# UNITED STATES PATENT AND TRADEMARK OFFICE

APPLICATION NO.	FILING DATE	FIRST NAMED INVENTOR	ATTORNEY DOCKET NO.	CONFIRMATION NO.
10/820,134	04/08/2004	Han Jun Sung	1594.1364	6666
21171	7590	03/14/2006	EXAMINER	
STAAS & HALSEY LLP SUITE 700 1201 NEW YORK AVENUE, N.W. WASHINGTON, DC 20005			EARLY, MICHAEL JACOBY	
			ART UNIT	PAPER NUMBER
			3744

<b>Office Action Summary</b>	<b>Application No.</b> 10/820,134	<b>Applicant(s)</b> SUNG ET AL.	
	<b>Examiner</b> Michael J. Early	<b>Art Unit</b> 3744

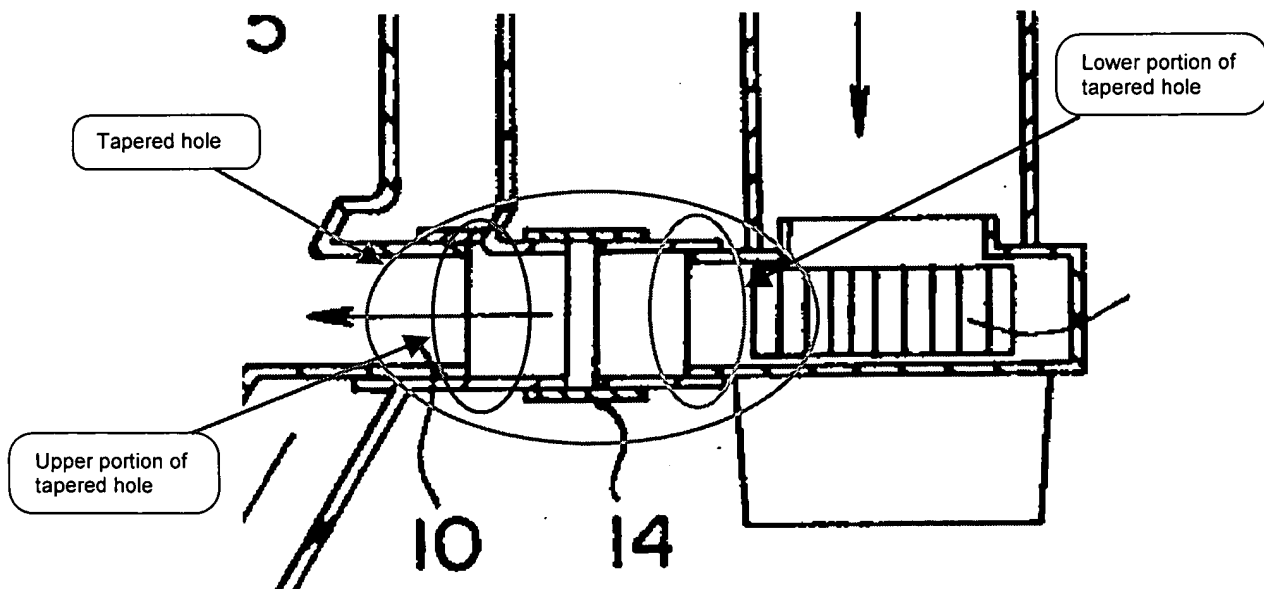
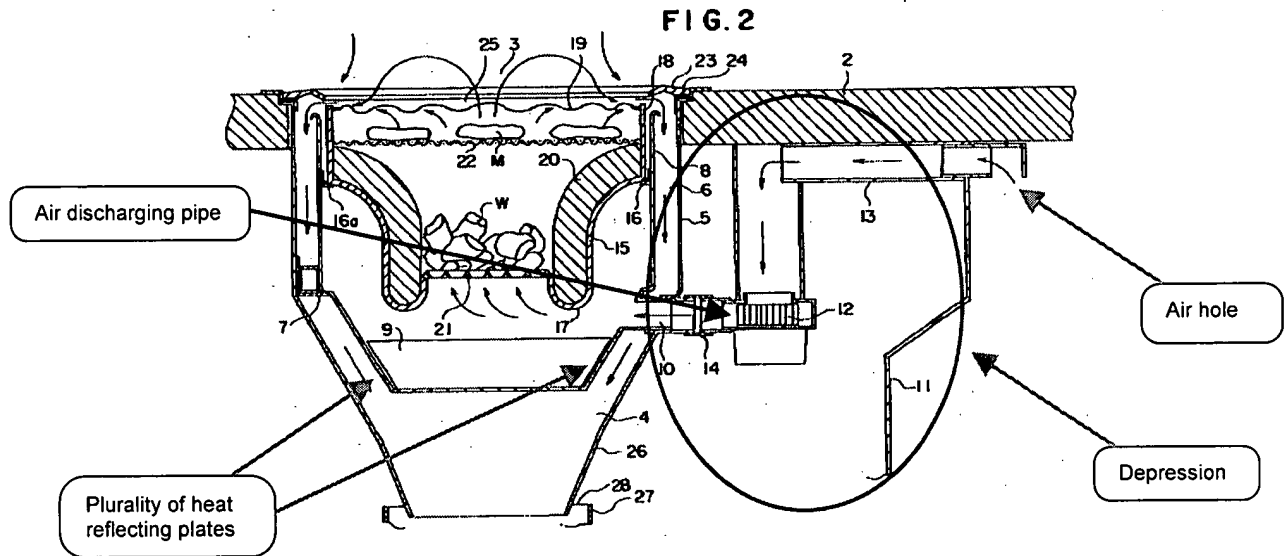
- the connection member comprises a tapered hole (as seen in the first exploded illustration of Figure 2 below) that is tapered in a direction from a top to a bottom of the connection member, the inlet of the grilling pipe being connected to an upper portion of the tapered hole (as seen in the first exploded illustration of Figure 2 below), and the air discharging pipe being connected to a lower portion of the tapered hole (as seen in the first exploded illustration of Figure 2 below) to allow the grilling pipe to be removably connected to the air discharging pipe using the connection member (inherent);

- the upper portion of the tapered hole has a diameter greater than an outer diameter of the grilling pipe (as seen in the second exploded illustration of Figure 2 below), the lower portion of the tapered hole has a diameter less

than the outer diameter of the grilling pipe (as seen in the second exploded illustration of Figure 2 below), and the diameter of the lower portion of the tapered hole is approximately equal to an outer diameter of the air discharging pipe (as seen in the second exploded illustration of Figure 2 below);

(First exploded illustration of Figure 2)

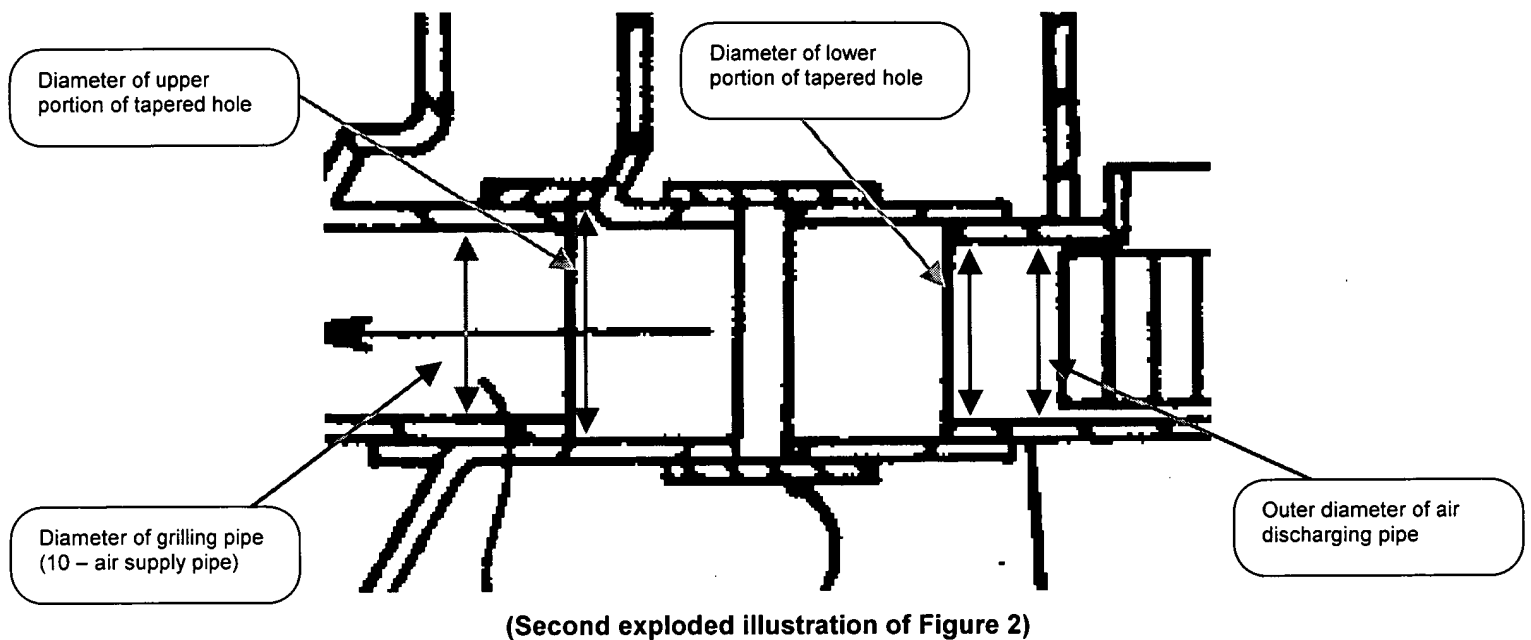
- an air discharging pipe (as seen in the first exploded illustration of Figure 2 above) to connect the blowing fan to the inlet of the grilling pipe, with air entering the grilling pipe by both the blowing fan and the air discharging pipe, and then being discharged to an outside of

- a connection member (14 – connecting pipe) provided on an upper portion of the cabinet to connect the air discharging pipe to the inlet of the grilling pipe (as seen in Figure 2), the connection member having a tapered hole (as seen in the first exploded illustration of Figure 2 above) that is tapered in a direction from a top to a bottom of the connection member, with the inlet of the grilling pipe being connected to an upper portion of the tapered hole (as seen in the first exploded illustration of Figure 2 above), and the air discharging pipe being connected to a lower portion of the tapered hole (as seen in the first exploded illustration of Figure 2 above) to allow the grilling pipe to be removably connected to the air discharging pipe using the connection member (inherent);

- a depression (as seen in the illustration of Figure 2 above) on a lower surface of the recess to receive the air cooling unit of the grill cooker, with an air hole (as seen in the illustration of Figure 2 above) on a surface of the depression to draw air into the air cooling unit to allow the grilling unit to be cooled by the air when the grill cooker is set in the recess, the air cooling unit being received in the depression (as seen in Figure 2);
